Re: Verona Landscape Changes

**Final Development Plan
Amendments
Verona Village**

Patio Homes Entry - Plan from FDP

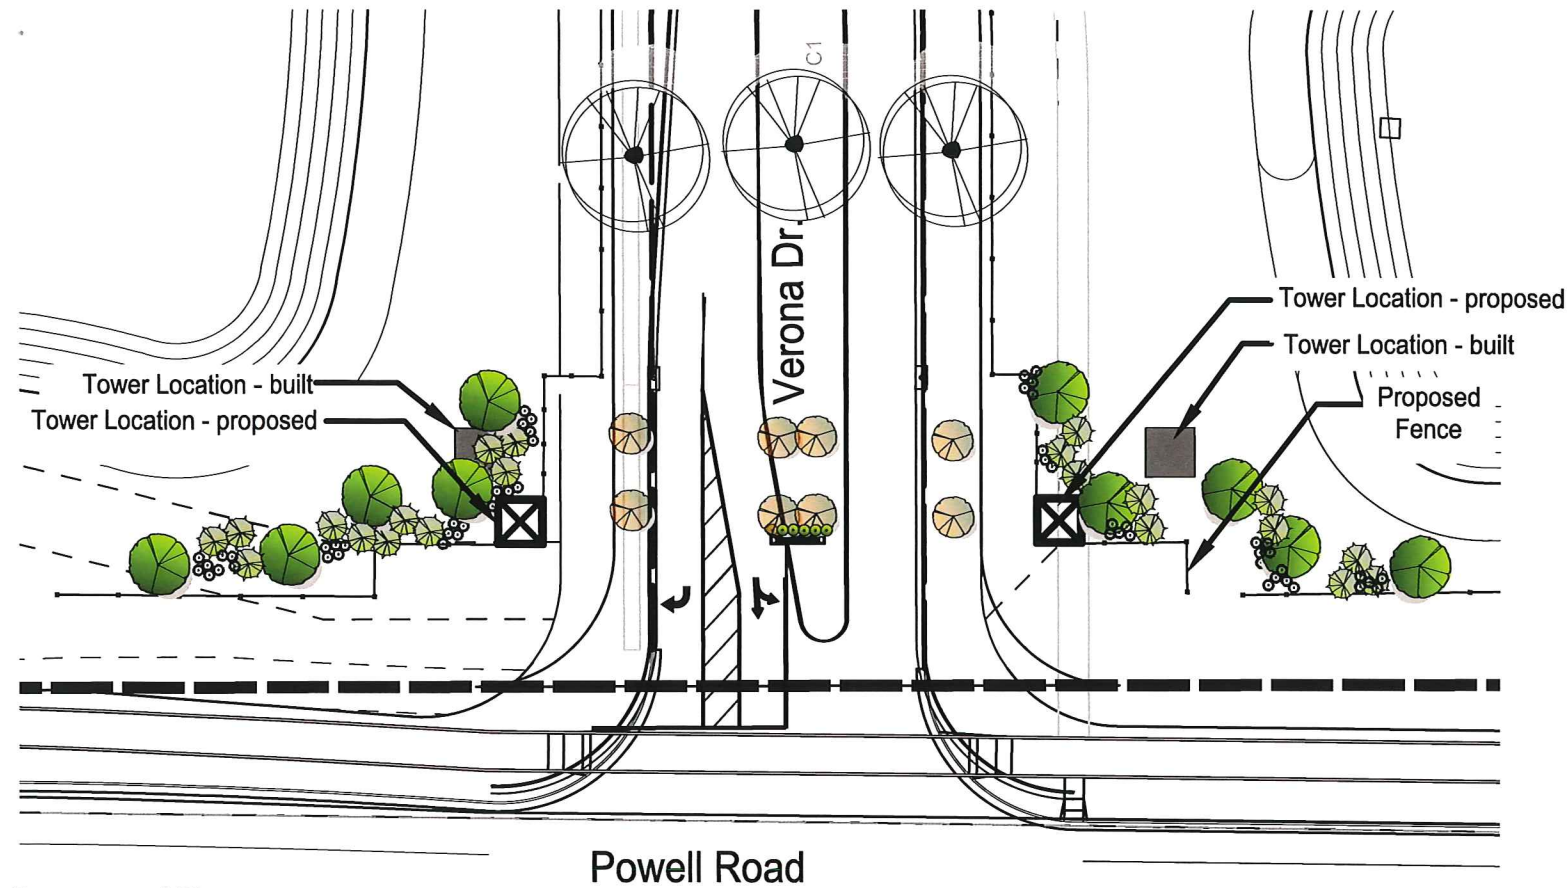
- 1. Eliminate the wood cross buck fence from the design
- 2. Eliminate brick pavers in the street as well as the brick walks , colonial benches and coach lights
- 3. Modify the column design and location

Reasoning: The Parade of Homes, as well as annexation to Powell, required a different approach to the overall style of the development's site features than that proposed on the Final Development Plan. Wood crossbuck fencing, brick walks, brick columns and colonial benches gave way to a European, Tuscan style. In addition, the developer desired to emphasize the Parade of Homes sites and de-emphasize the patio homes.

As a result, the columns are now primarily stone with brick used as an accent, precast concrete caps with large overhangs replaced the slate roofs, a logo was added to the plaque and the columns were moved closer to the road. In addition, the columns proposed at the north end of the patio homes were not installed to minimize the visual impact of these secondary entrances.

The ornamental trees at each entry were installed per the FDP as well as evergreen trees along the sides of homes, shade trees were increased in size and quantity from the FDP and plants were added to the column's bases: 14 perennials, 7 ornamental grasses and 8 shrubs were installed at each column.

Lift Station with sign and architectural enhancements

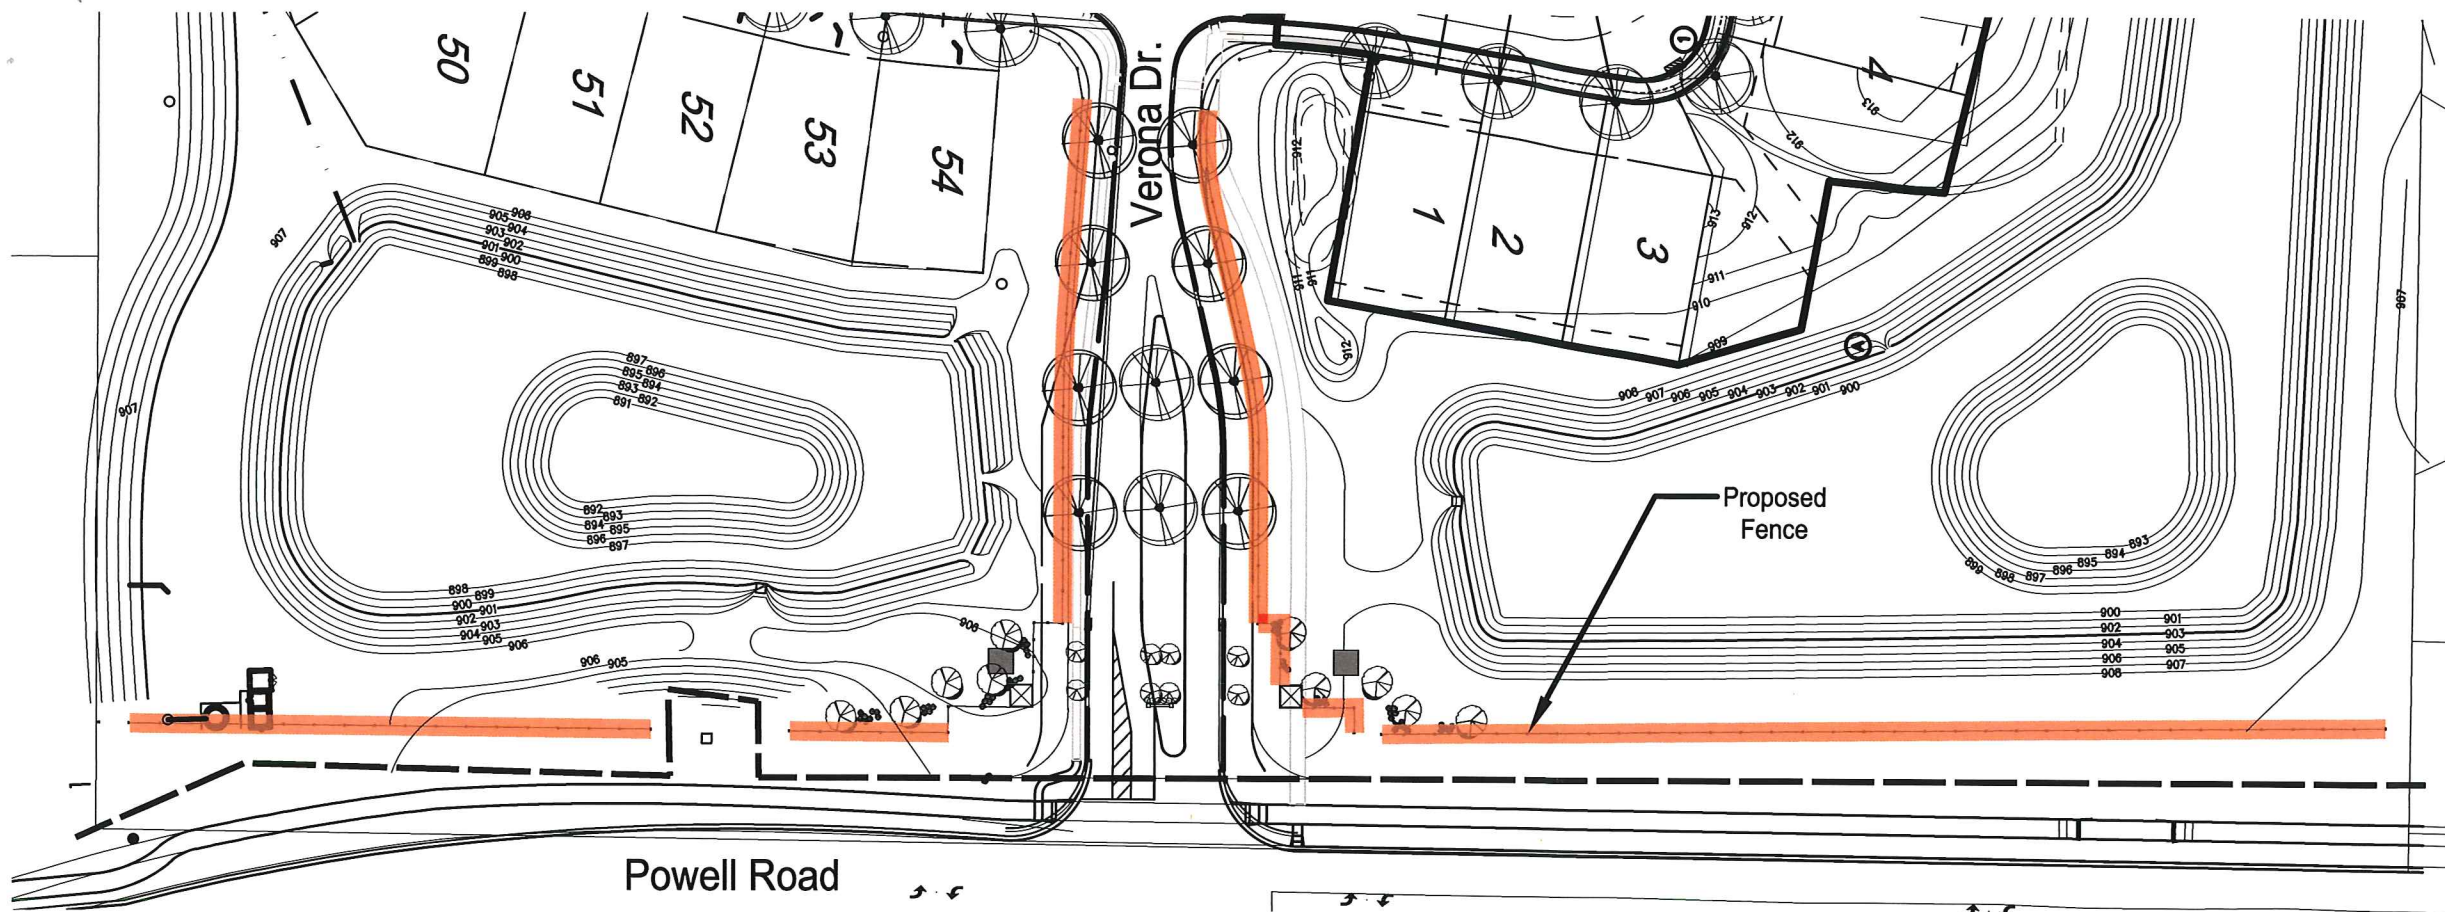
1. Relocate sign from median to lift station building
2. Modify style of towers
3. Modify plant types and locations

Reasoning: The Parade of Homes, as well as annexation to Powell, required a different approach to the overall style of the main entrance than that proposed on the Final Development Plan. The median was refined during the engineering phase resulting in an island more narrow than originally planned. This made placement of the sign difficult. Plus, the addition of the lift station at a highly visible location along Powell Road presented a better location for the sign. Thus, the sign was moved to the lift station and, along with other architectural enhancements, provided an opportunity to greatly improve the appearance of the building.

The materials and proportions of the towers were modified to fit the desired European Tuscan theme and plaques with the name and logo were added. 8 ornamental trees, 20 deciduous trees, 20 evergreens and 54 ornamental grasses were shown on the FDP at the entry; 23 tall evergreens and 15 deciduous trees as well as decorative river wash gravel were installed.

Powell Road Frontage - Plan from FDP

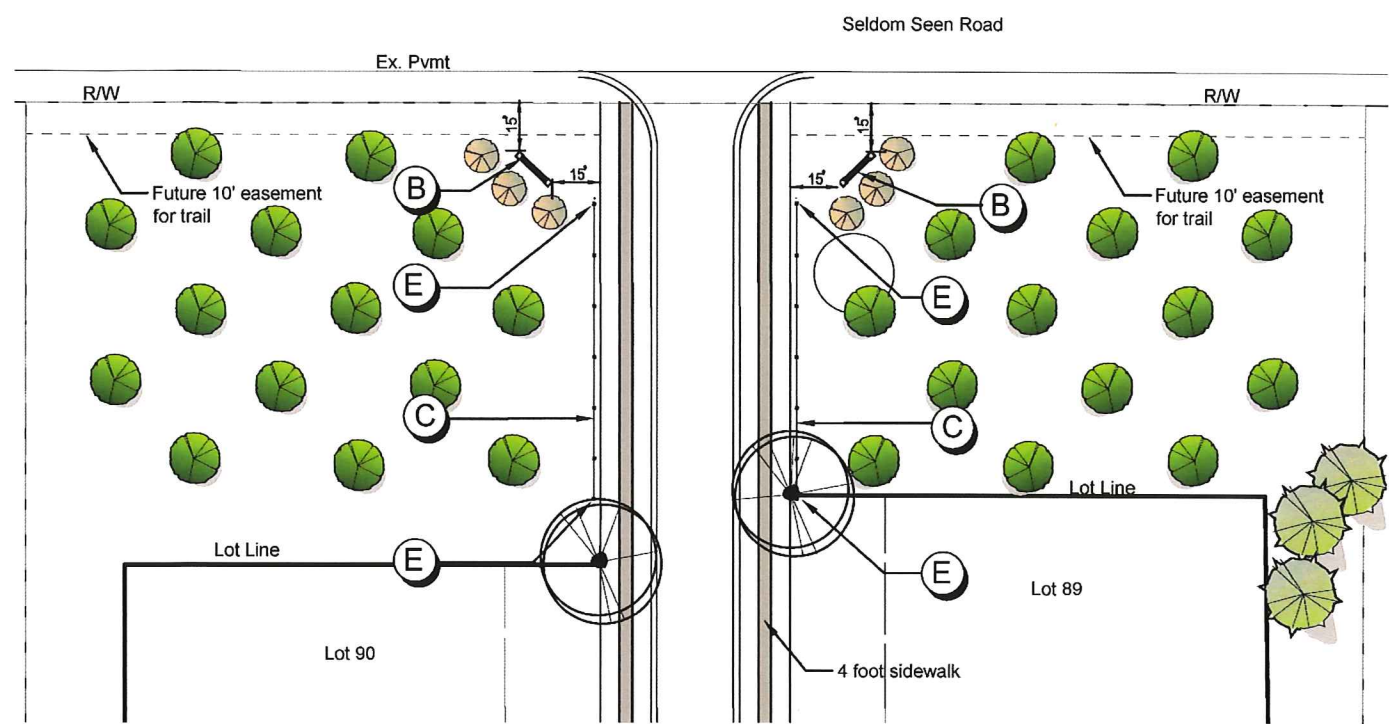
Summary of Changes:

1. Eliminate the wood cross buck fence from the design
2. Increase buffering using mounds and a mix of evergreen and deciduous trees

Reasoning: The Parade of Homes, as well as annexation to Powell, required a different approach to the overall style of the Powell Road frontage than that proposed on the Final Development Plan. The wood crossbuck fence was replaced as the primary frontage element in favor of continuous grass mounds and trees. This created an image that reinforced the European, Tuscan style of the entry towers and columns. This also created a much stronger visual and sound barrier between the widened roadway and proposed homes. 63 evergreens, 63 deciduous trees and 27 ten-foot tall arbovitae were installed along the frontage where no plants were previously proposed: representing a substantial increase over the FDP.

Seldom Seen Entry - proposed on FDP

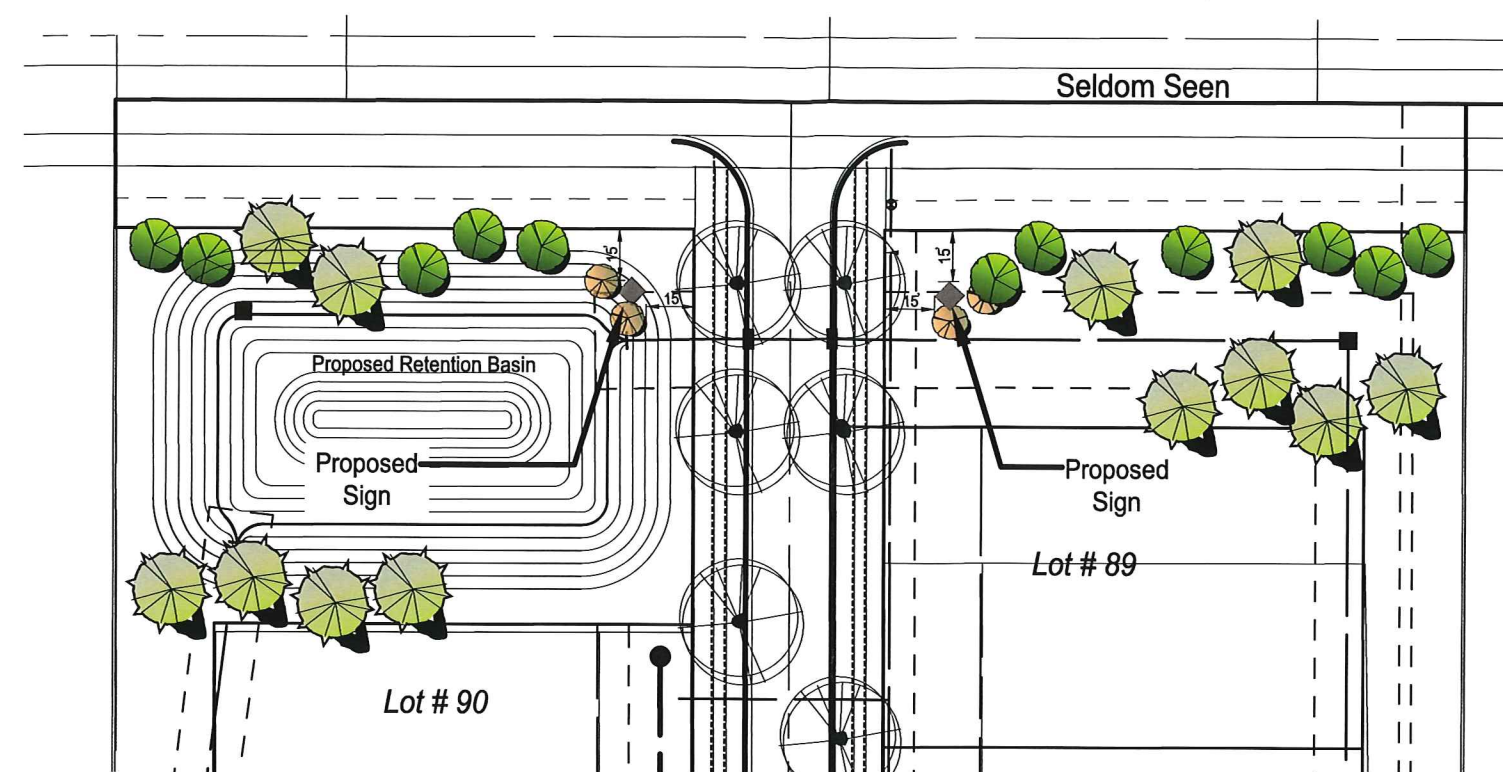
Summary of Changes:

1. Eliminate the wood cross buck fence from the design
2. Revise placement of trees
3. Revise sign location and style

Reasoning: Plant and sign locations need to be modified in order to avoid a retention basin and other utilities that have been added to satisfy engineering requirements. Other changes to this secondary entry are the result of matching the European Tuscan style of the other site features in phase 1 and 2. A mix of evergreen and deciduous trees are proposed along the Seldom Seen frontage to match the landscape along Powell Road.
